20 September 1965

Enclosed you will find prints of the layout of the micrometer stage for light table # 2. The unit will meet all of your requirements as far as stereoscope position, working distance and accuracy requirements. The unit will not fit within the envelope specified for light table # 2 due to its length in the Y-Y direction. An overhang of 31/4" exists at the rear of table # 2 and 21/4" will exist at the rear of table # 3. This overhang cannot be eliminated as it would require moving the rear X-X precision way. This modification would degrade the accuracy of the entire motion in both X and Y.

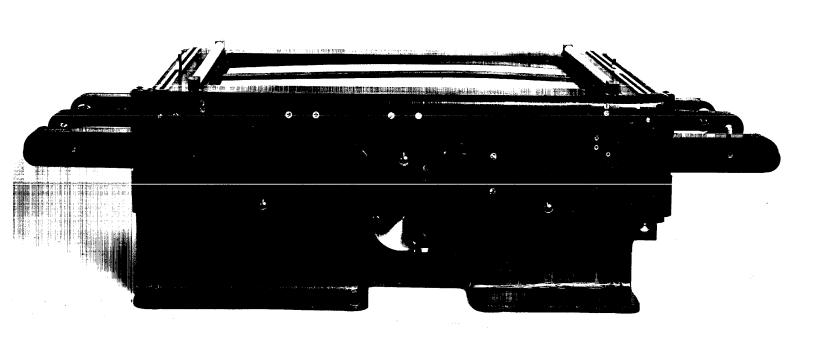
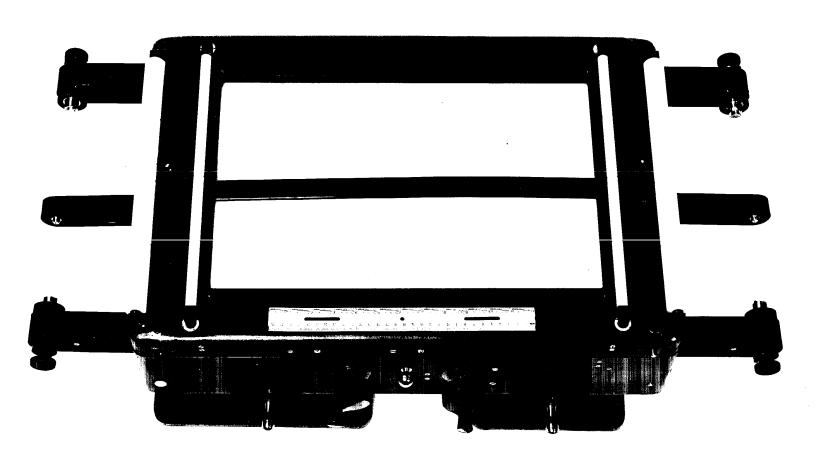
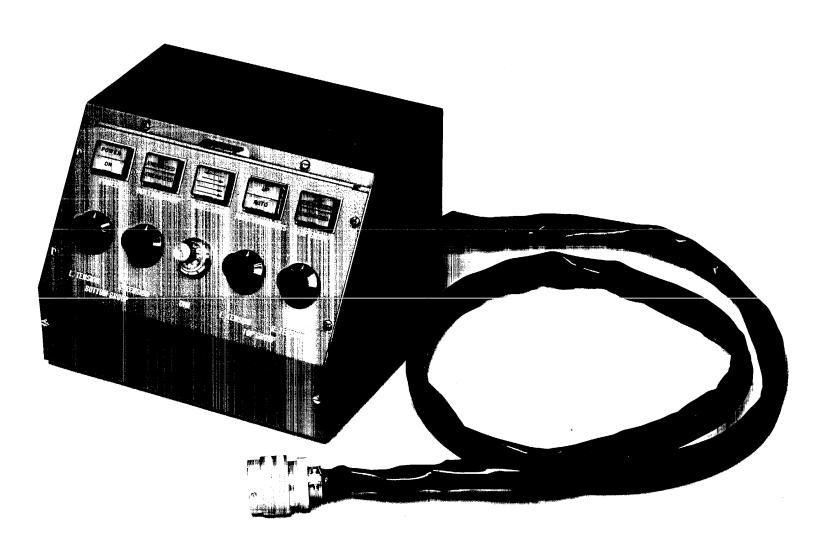
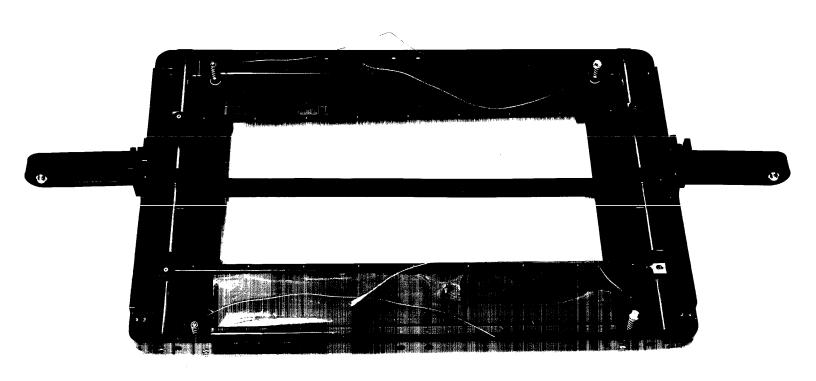
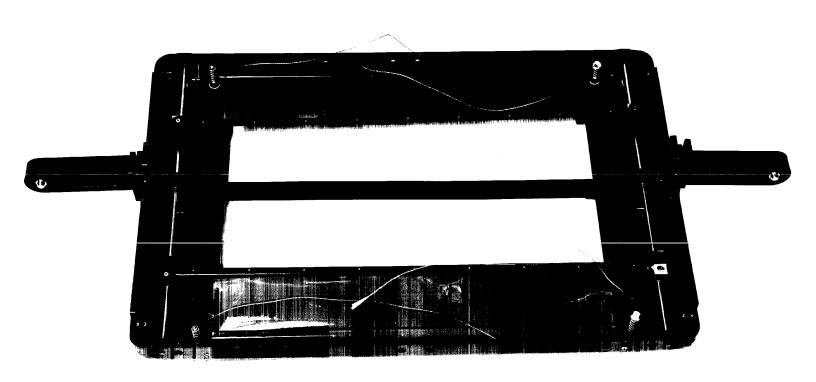
Will you please examine the drawing and tell us if this overhang is permissible. We would like to have an answer as soon as possible as the extablishment of a delivery date for light tables # 2 and # 3 is predicated upon your decision.
